Engineering Change Notice

Title	EZ DMX Oscillator Modification
ECN Number	ECN-0147
Equipment	
Author	Adam Proffitt
Drawing Number	
Date	03/12/2002

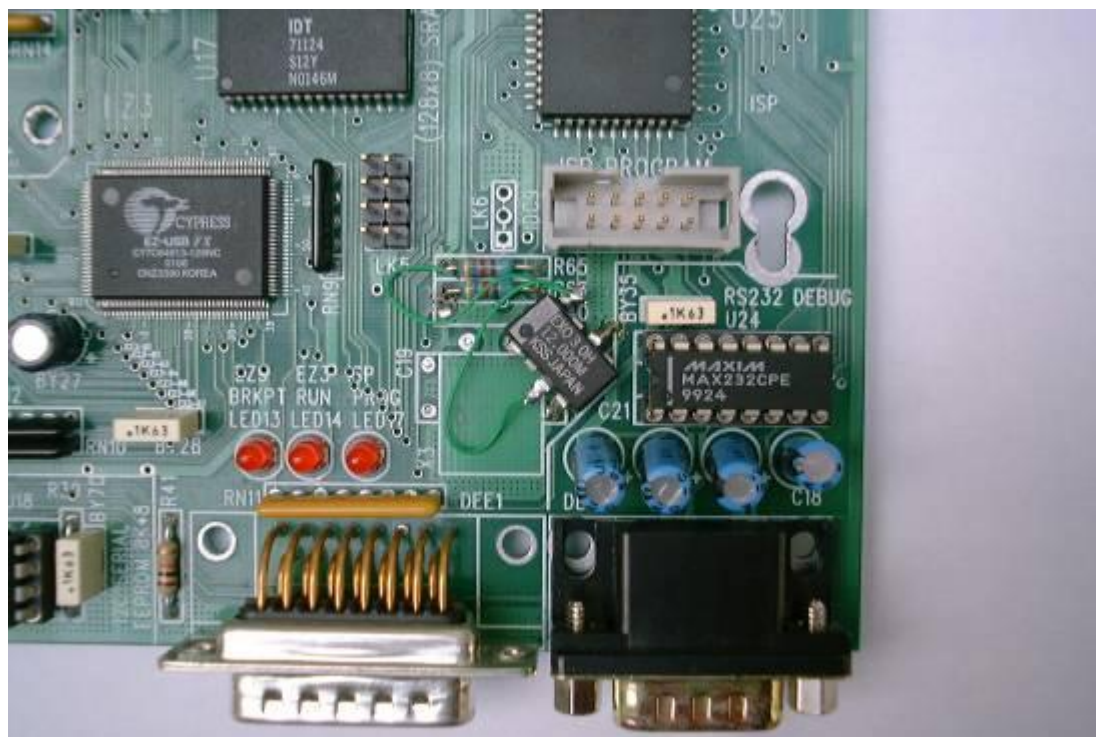
Reason for ECN	Crystal circuit gives noise on internal pll.
Special Parts required	12MHz Oscillator EXO3 (05-03-0417)
Special Tools required

1. Remove crystal oscillator components X3,C19,C20,R40.
2. Break off pins 2,5 and 7 of EXO3 oscillator.
3. Bend up and trim pins 3 and 8.
4. Solder pins 1, 4 and 6 into holes of the pcb as shown in photo.
5. Connect 3V3 supply wire from R65 to pins 3 and 8.
